YANKEE ATOMIC ELECTRIC COMPANY

Subject: Response to the NRC Questions on RELAP5YA

RESPONSE TO 80 QUESTIONS
ON RELAP5YA

July 1, 1985

Figure I.3-2 Effect of Noncondensibles on Heat Rate - Maine Yankee

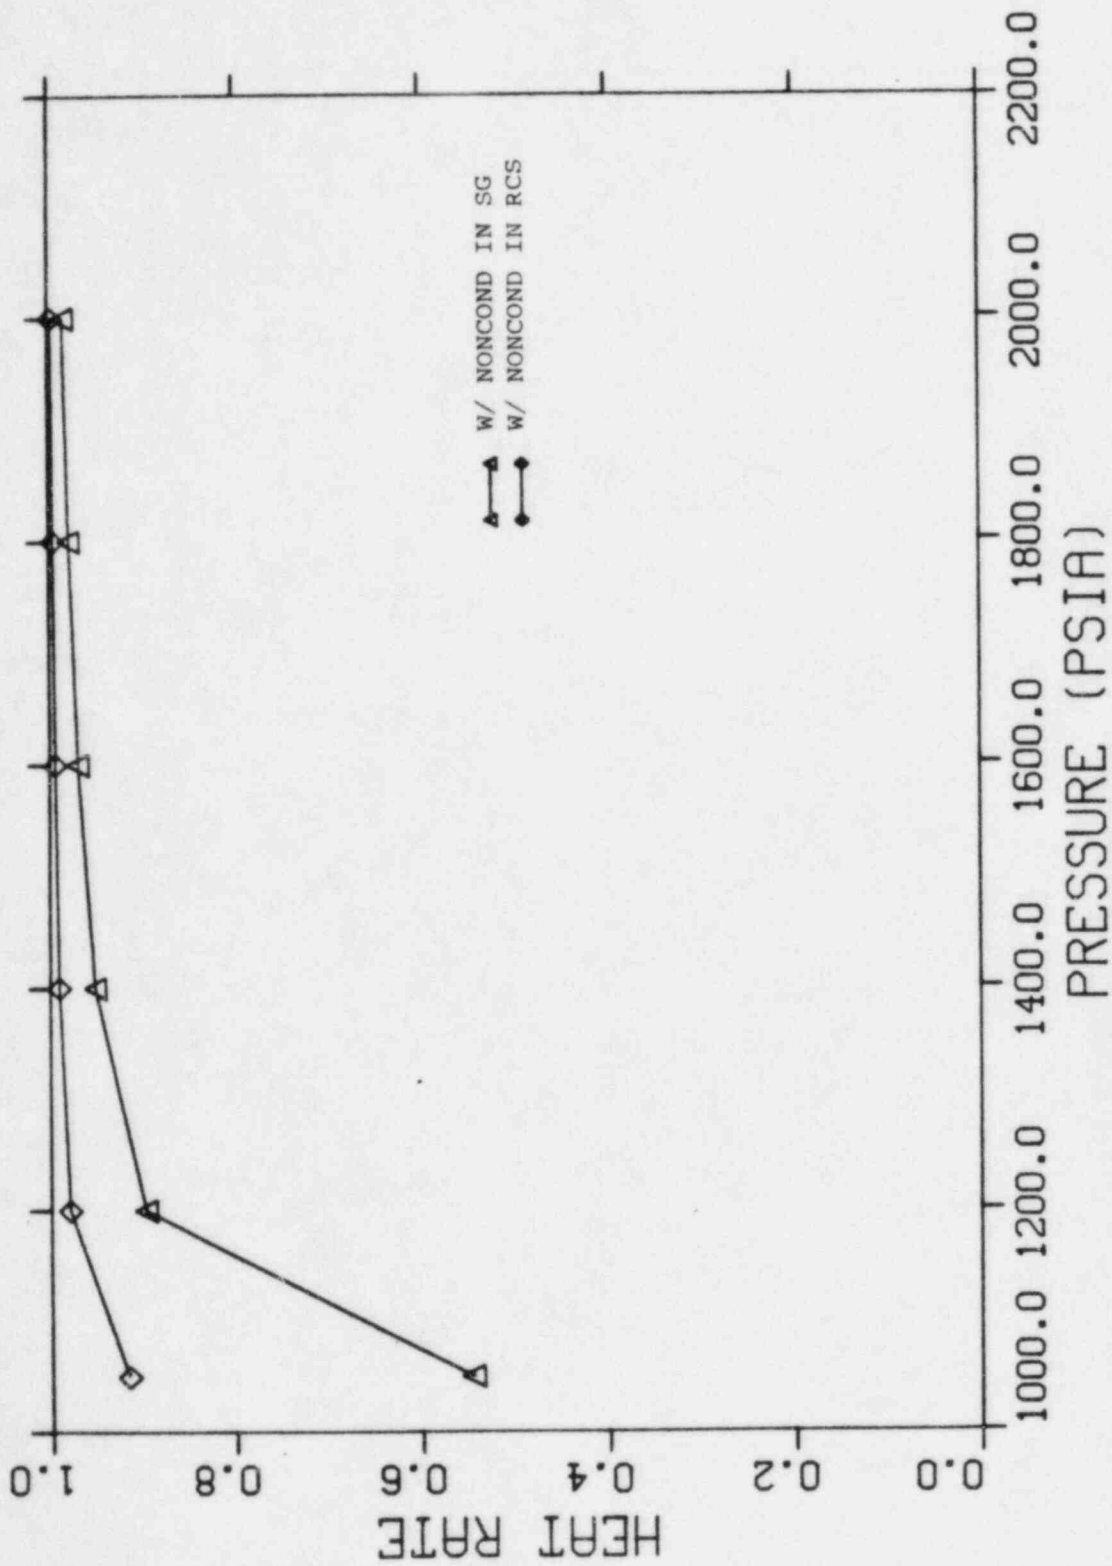
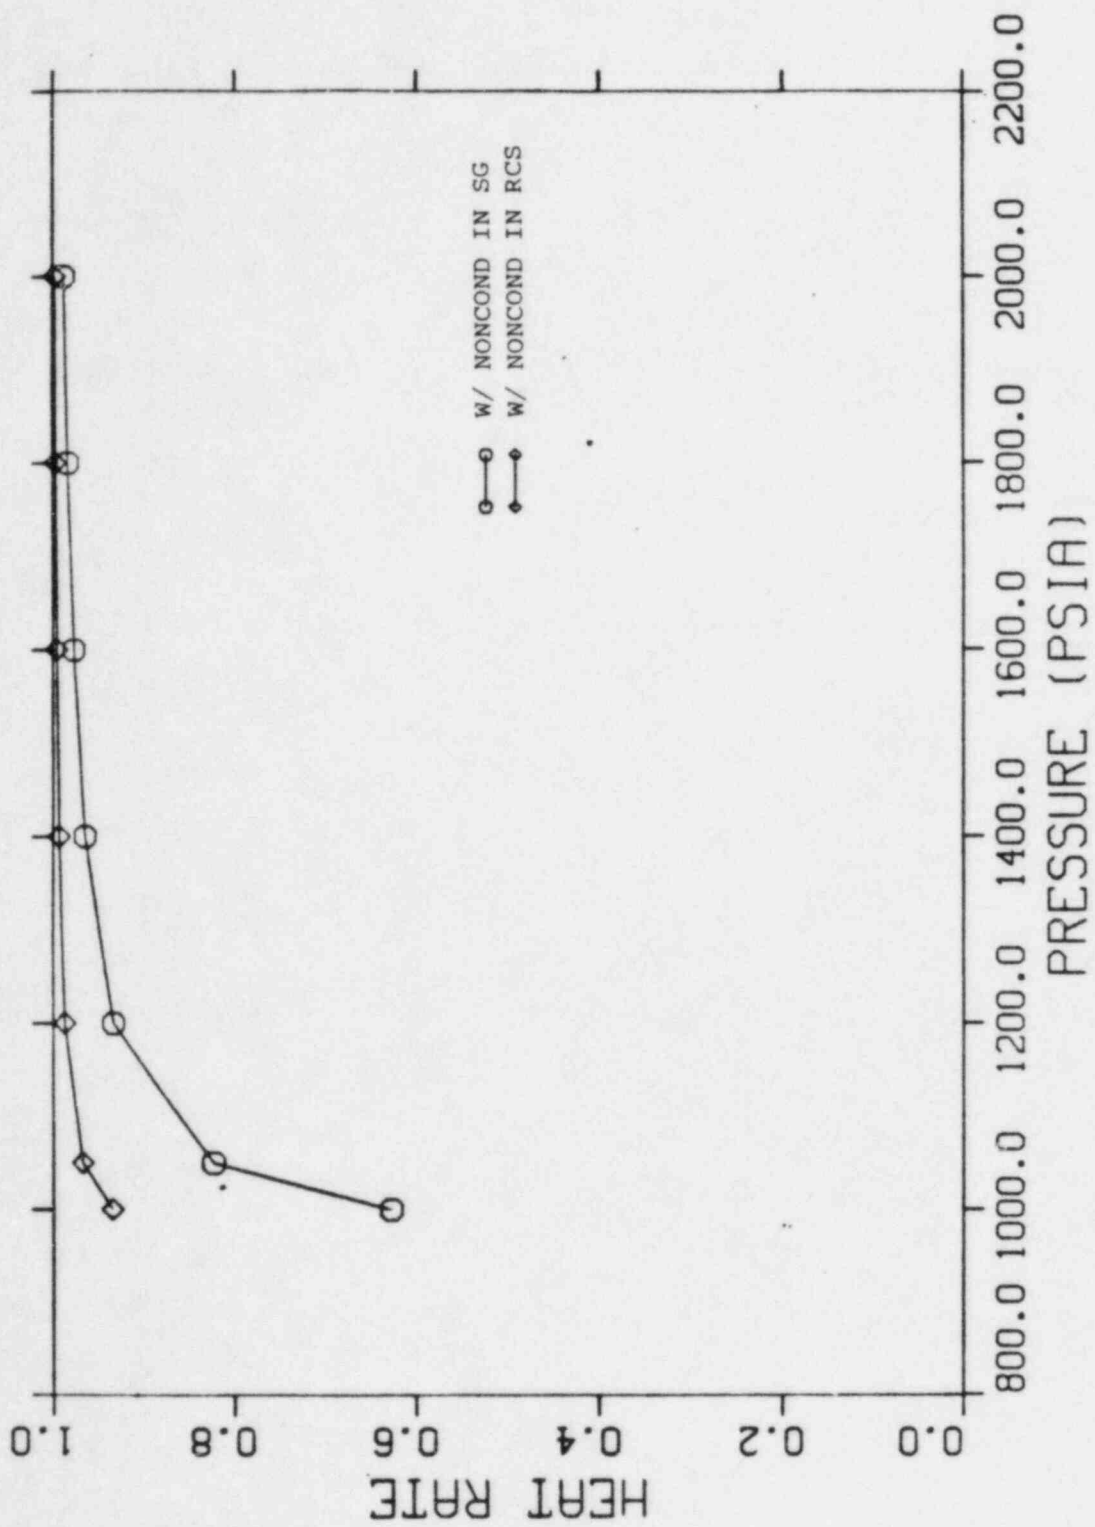
Clarify which of these are treated by RELAP5YA and what rates are used to predict the amounts entering the system from each source.

Figure I.3-2 and I.3-3 give the results of these calculations as a function of primary side pressure for the Maine Yankee and Yankee plants, respectively. The top curve corresponds to the case where the noncondensable was evenly mixed throughout the entire primary system. The bottom curve in each graph corresponds to the case where the noncondensable was uniformly

distributed in the steam generators only. The graph's ordinate represents the heat flux with noncondensibles divided by the heat flux without noncondensibles for the same primary side pressure. As the curves show, for a primary side pressure which is approximately 200 psia greater than the secondary side pressure, the reduction in heat transfer is less than 10% for Maine Yankee and about 13% for the Yankee plant. Due to the large heat transfer area (151403 ft^2 for Maine Yankee and 42575 ft^2 for Yankee) available for condensation, this type of reduction presents no problem.

Figure I.27-1 Comparison of Calculated Accumulator Pressures With and Without Evap/Cond. for Maine Yankee Test

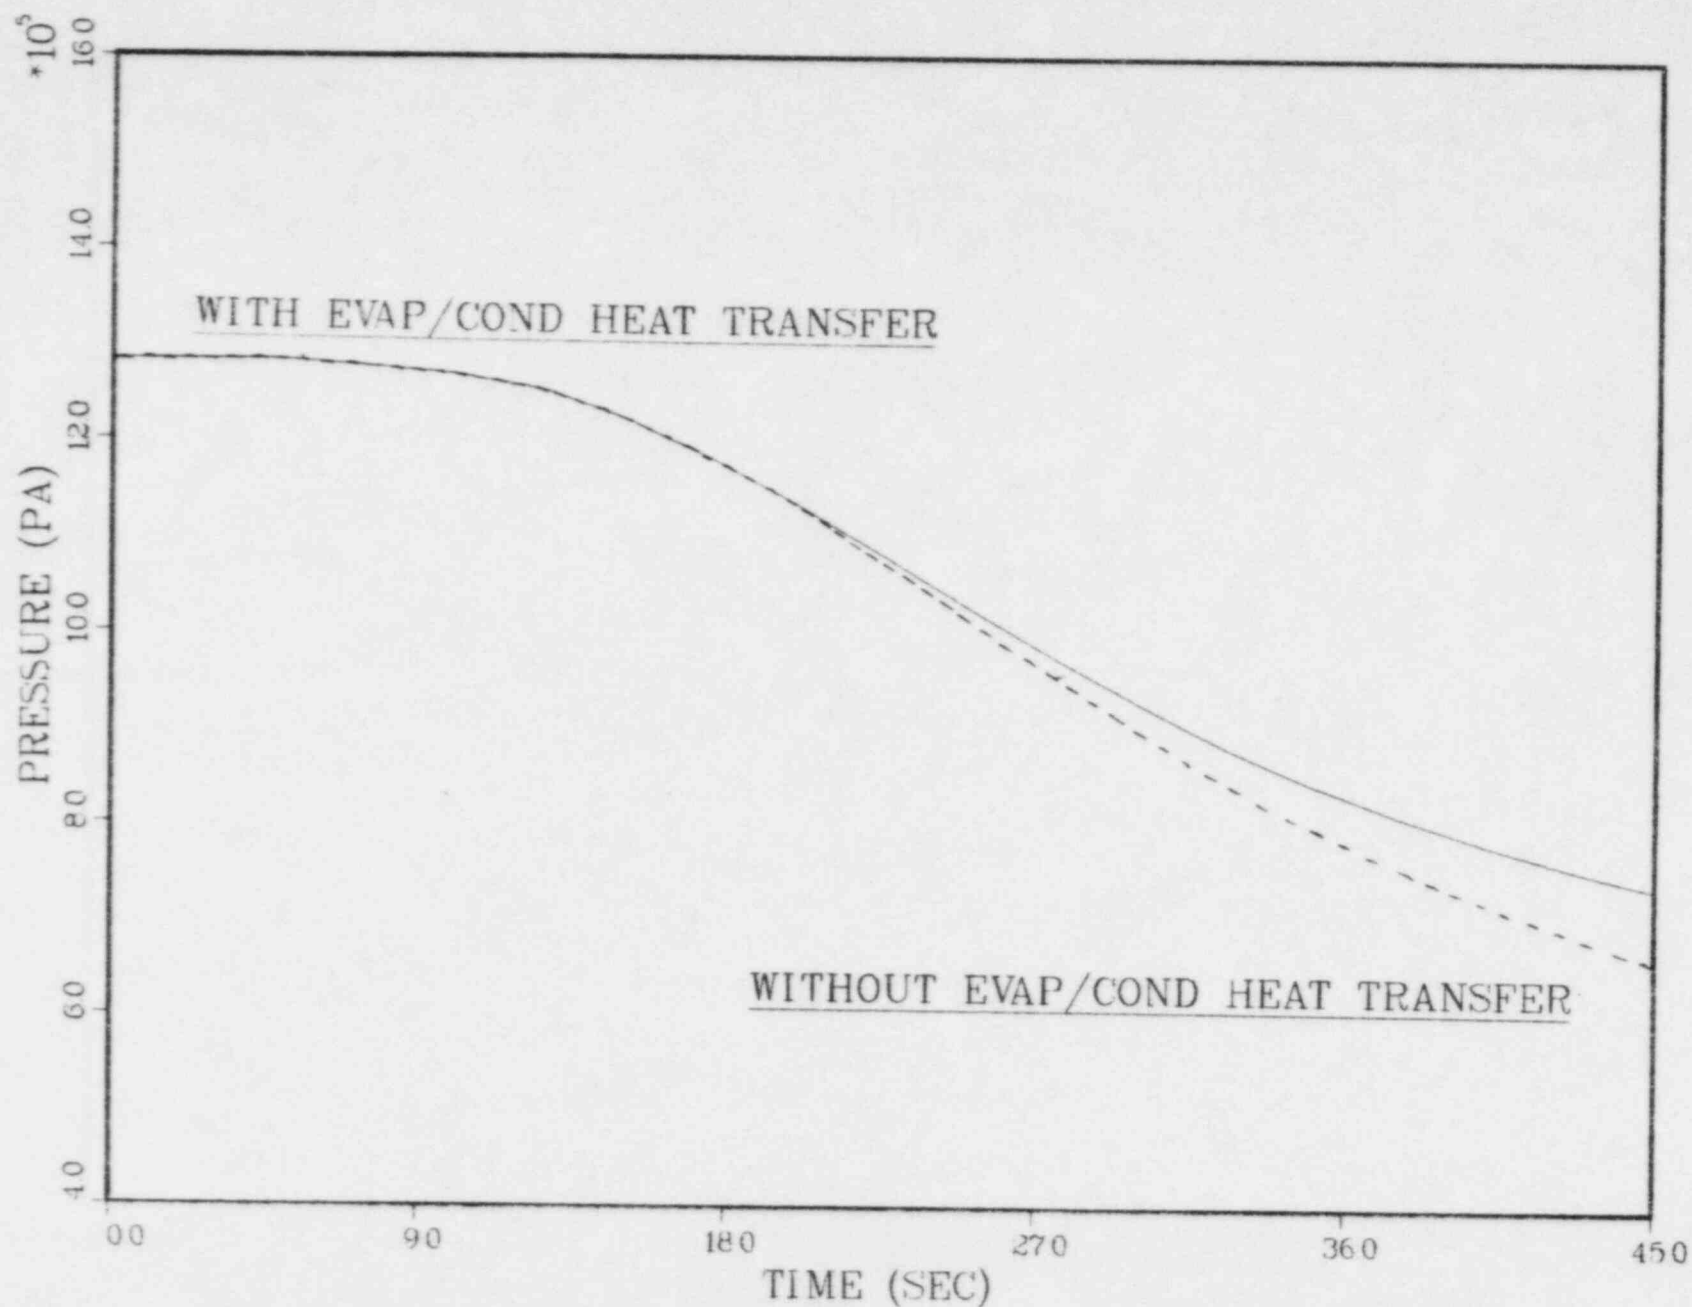
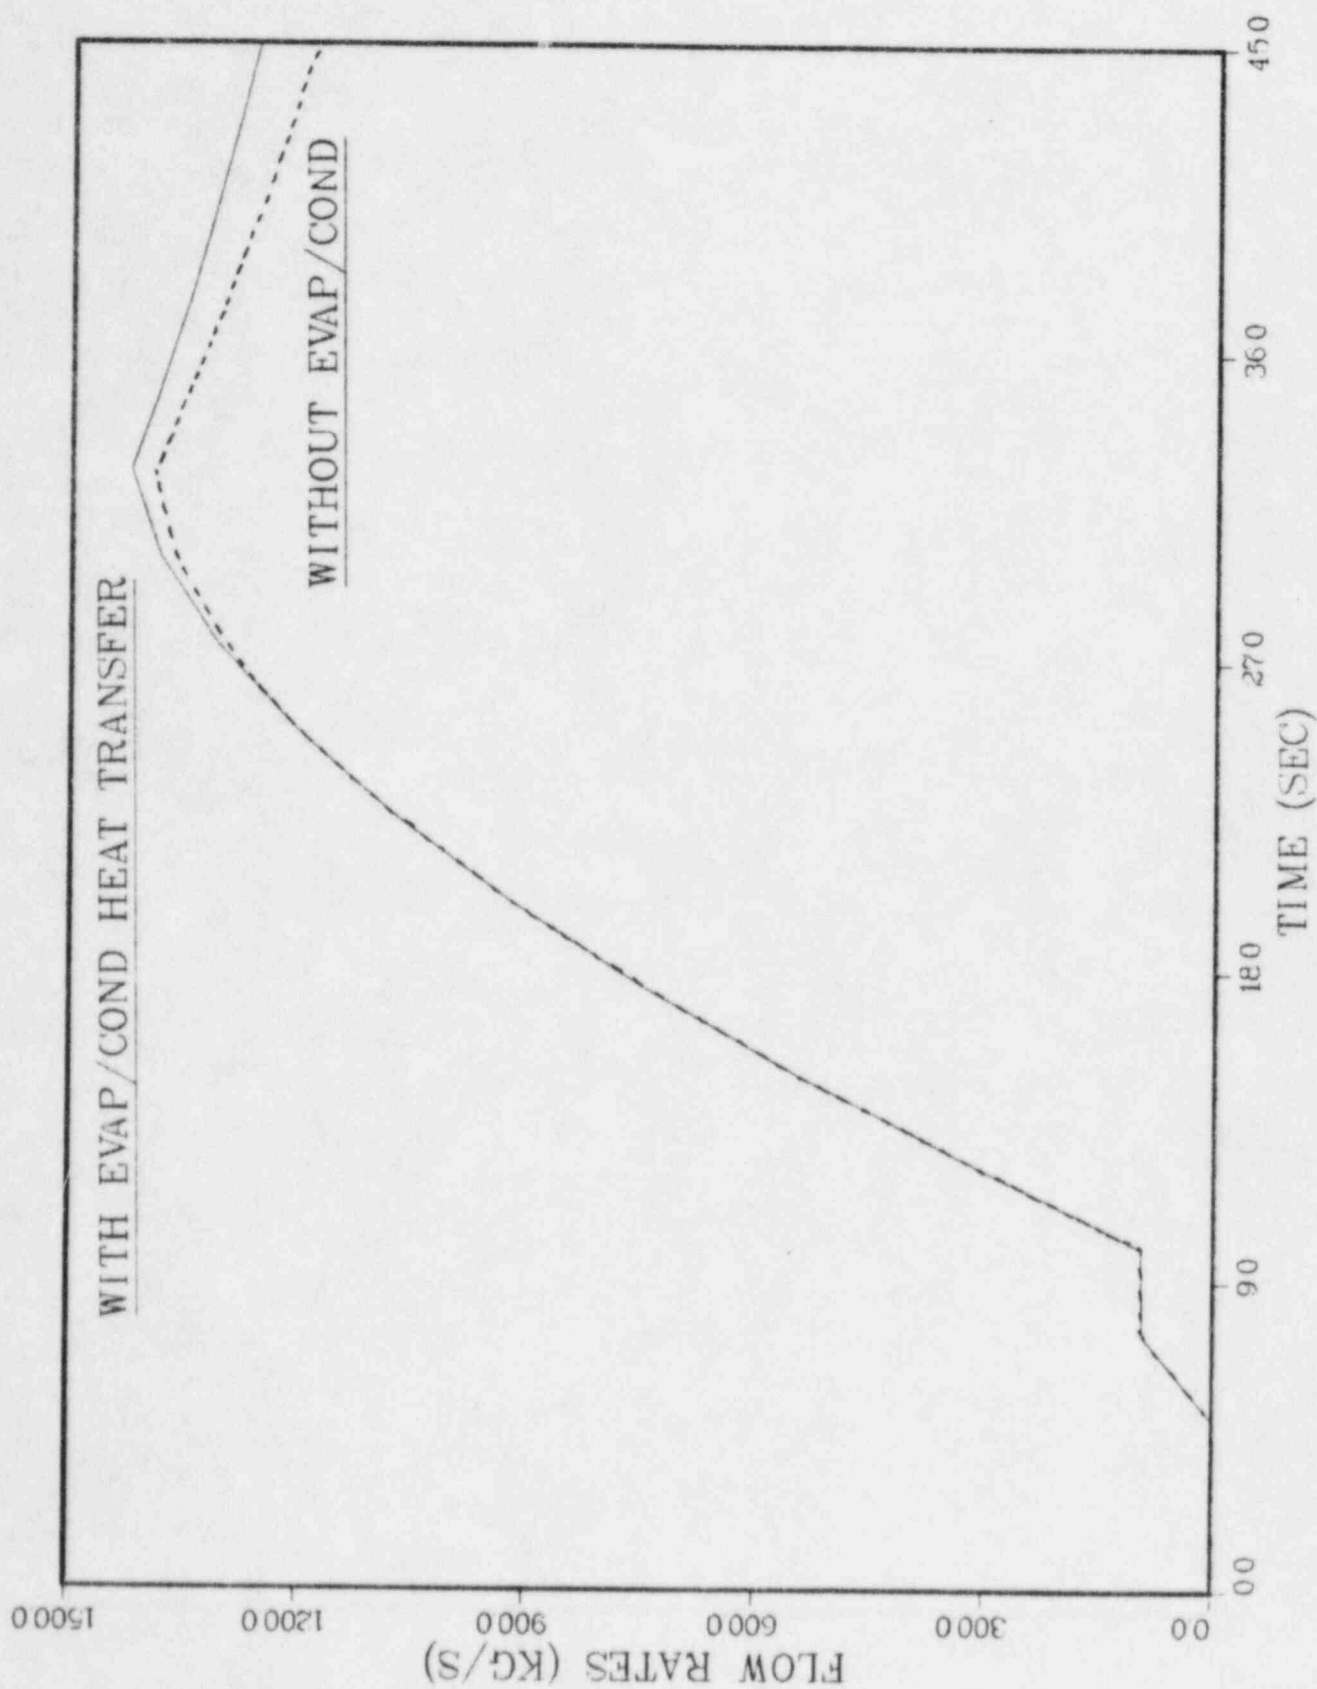
Clarify how much effect the evaporation and condensation in the accumulator will have on the calculated pressures and injection rates for SBLOCAs.

Figure I.28-1 Valve Area History During The Maine Yankee Test

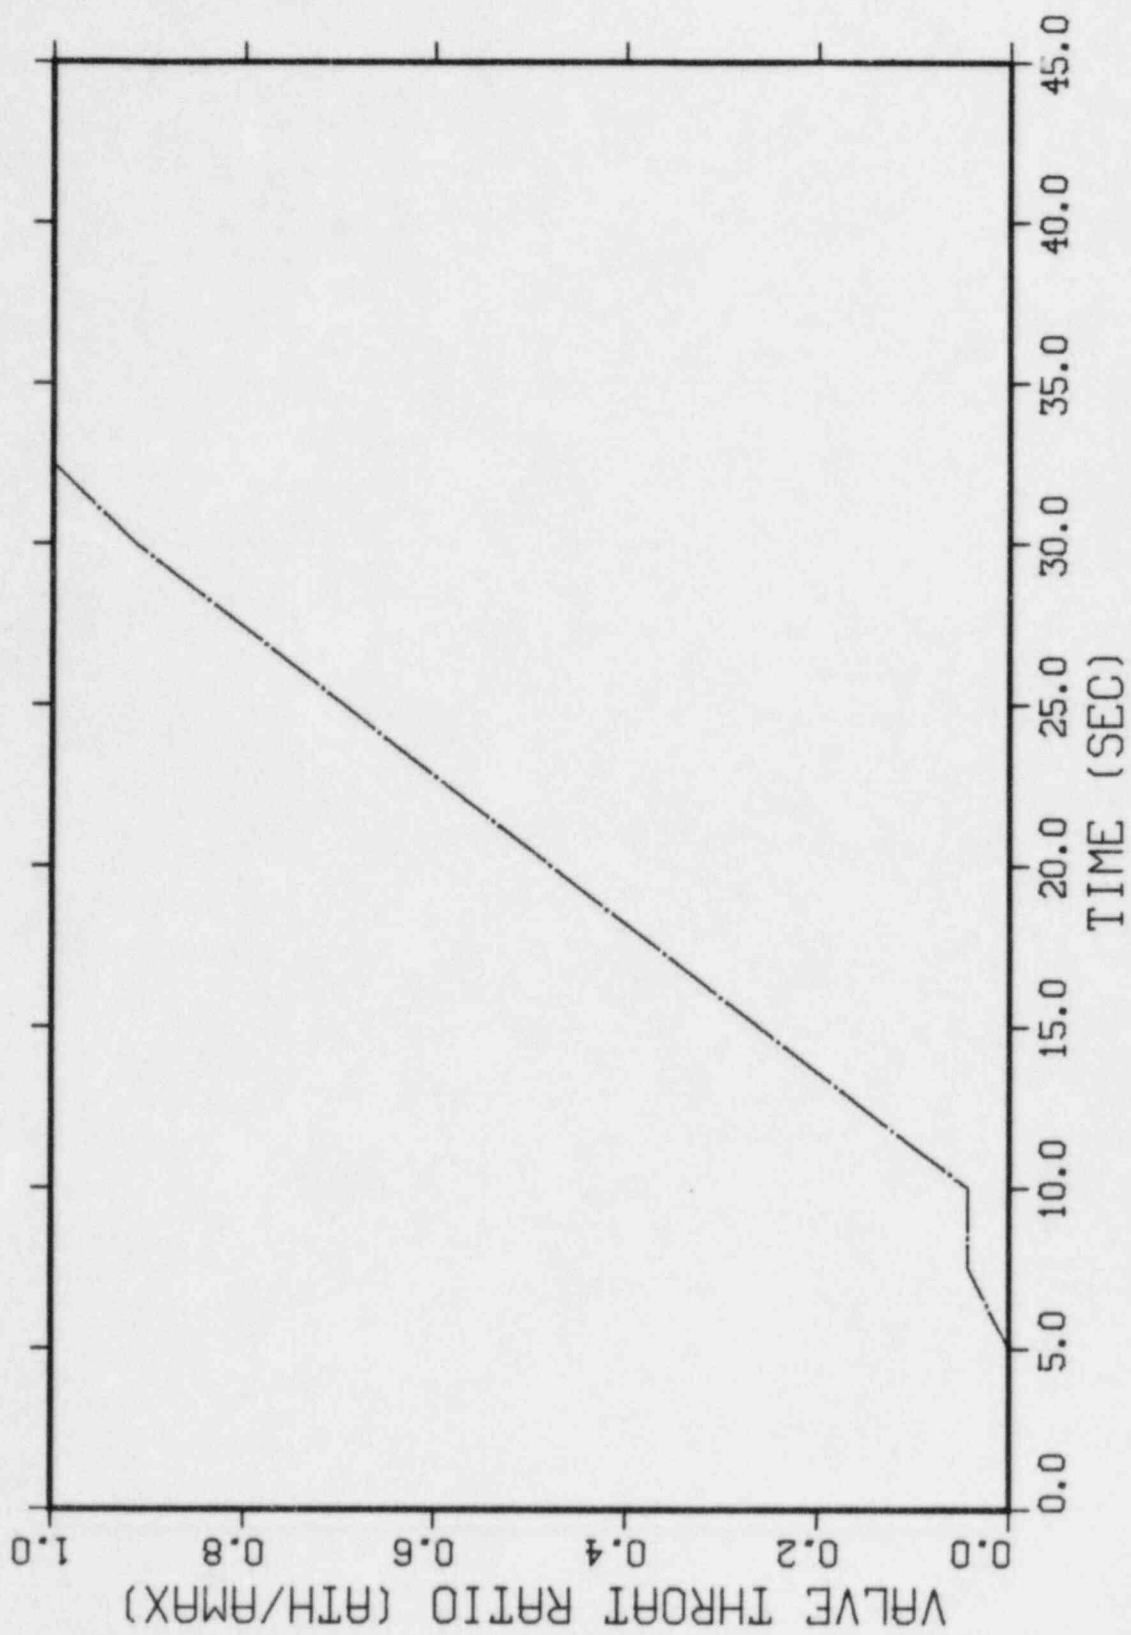
The following questions are concerned with the calculation of the Maine Yankee accumulator test presented in Section 2.4.1 of Reference 12. page 87 of Reference 12 says that the "valve took approximately 23 seconds to reach the fully open position." Table 2.4-1 of Reference 12 shows a fixed friction factor and form loss coefficient. Clarify how the valve opening process was modeled, especially because almost half of the 48s transient involved the valve opening time. Figures 2.4-1 and 2.4-2 of Reference 12 do not indicate which curve is the data and which is the RELAP5YA result.

The friction factor and form loss factor given in Table 2.4-1 apply to the surge line and its connection to the accumulator tank. The valve opening process is modeled utilizing the motor valve (MTRVLV) component as described in Section 7.10 of Reference I.23-1. A trip logic is combined with an appropriate valve opening speed resulting in valve throat ratios as shown in Figure I.28-1. This valve area history is believed to simulate the actual valve opening process. The variable form loss coefficient for the valve opening is calculated by the abrupt area change model associated with this component.
